P-16094

JINDAL ALUMINIUM LTD.
BANGALORE-560073 (INDIA)

| | NAME | DATE |
|----------------------|------------|---------------|
| 35104 | | 35104-ISSUE-3 |

| DESCRIPTION | MISC. SECTION |

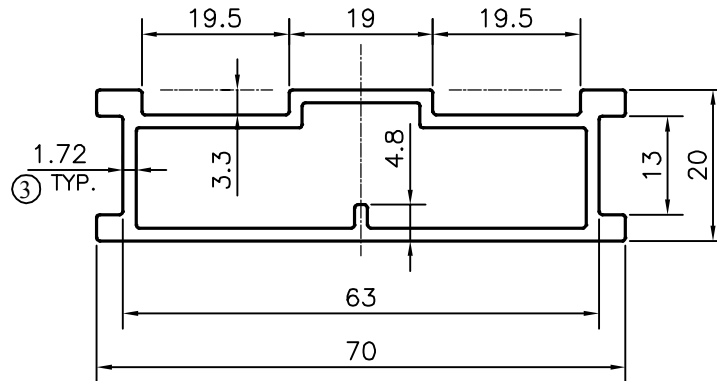
ISSUE-2

THICKNESS CHANGED FROM 1.8 TO 1.55 mm.

WEIGHT ALSO CHANGED FROM 0.963 TO 0.859 Kg/m.

ISSUE-3

THICKNESS CHANGED FROM 1.55 TO 1.72 mm.

WEIGHT ALSO CHANGED FROM 0.859 TO 0.930 Kg/m.
